# SAN FRANCISCO PLANNING DEPARTMENT

## Discretionary Review Full Analysis

*Date:* March 10, 2011  
*Case No.:* 2010.0367DD  
*Project Address:* 54-62 Peralta Street  
*Permit Application:* 2009.1231.4050 / 2009.1231.4052  
*Zoning:* RH-2 (Residential, Two-Family) District  
40-X Height and Bulk District  
*Block/Lot:* 5512 / 029, 031  
*Project Sponsor:* M. Brett Gladstone, Esq.  
Gladstone & Associates  
177 Post Street, Penthouse  
San Francisco, CA 94108  
*Staff Contact:* Ben Fu – (415) 558-6613  
ben.fu@sfgov.org  
*Recommendation:* **Do not take DR and approve the project as proposed.**

SIDEWALK IN FRONT OF  
54-62 PERALTA AVE.  
SHOWING SIDEWALK  
GRADE INCREASE AND  
RETAINING WALL/CURB CUT.

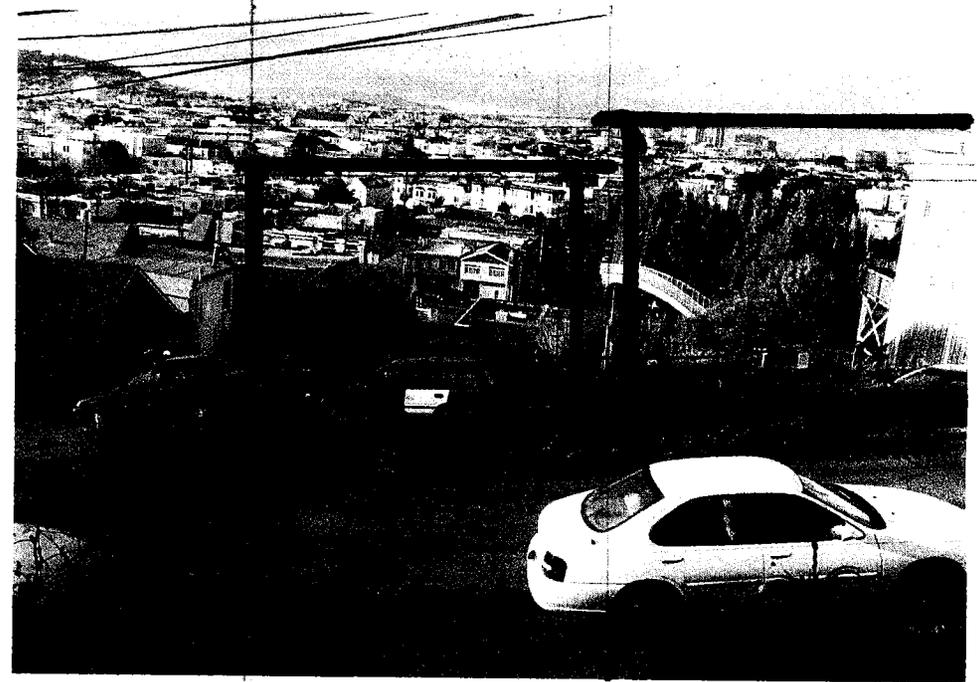
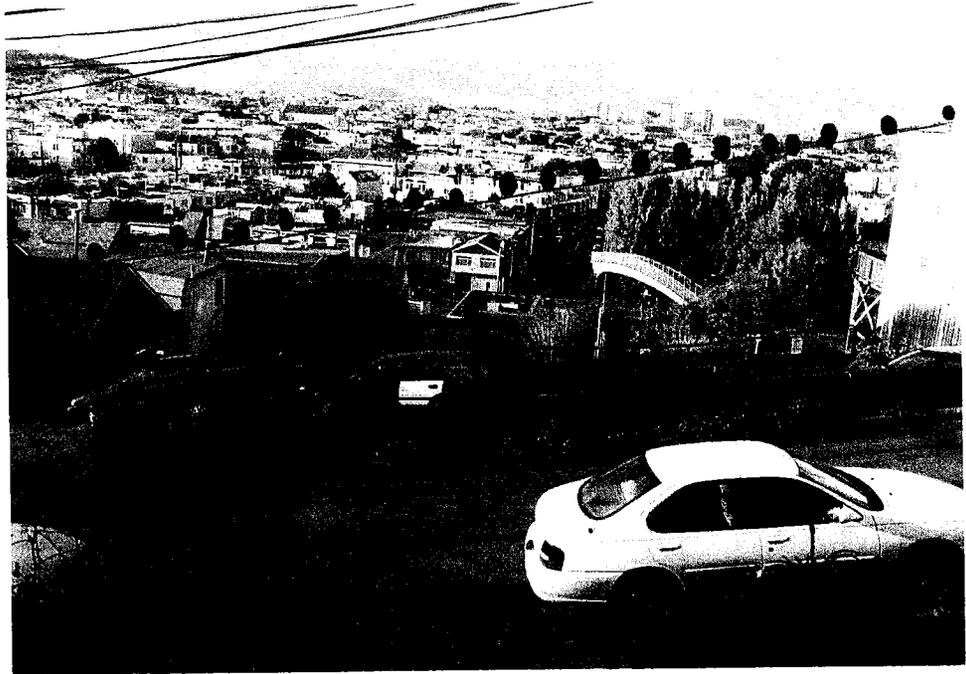
The plans show a sidewalk grade increase of nearly 4% from 16.6% to 20% (Please see page 21A). This slope increase is to create a level entry into the proposed underground parking area. This increase in sidewalk slope creates a hardship for many of the older residents in our neighborhood and without adequate information or dialog with the Developer and Owner we are concerned about the feasibility and safety of this design.

B. ***The plans do not contain sufficient information about the repairs to sidewalk grade and removal of a portion of the retaining wall to accommodate the driveway and garage.*** That information has been shown to neighbors on page A-3.0 of the plans. In order to provide the parking, a driveway is necessary. The driveway's location was chosen because it would

require the least amount of grade change and least amount of additional removal of the street's concrete barrier; and avoid a bridge over sidewalk. This bridge would be required if the driveway were located any more downhill toward Hampshire Street. The East Slope Design Review Board recognized that a driveway cannot be created for 60-62 Peralta Avenue. The new driveway across the uphill property sidewalk will not be steep at the entrance to the street. (See A-3.0 of the plans.)
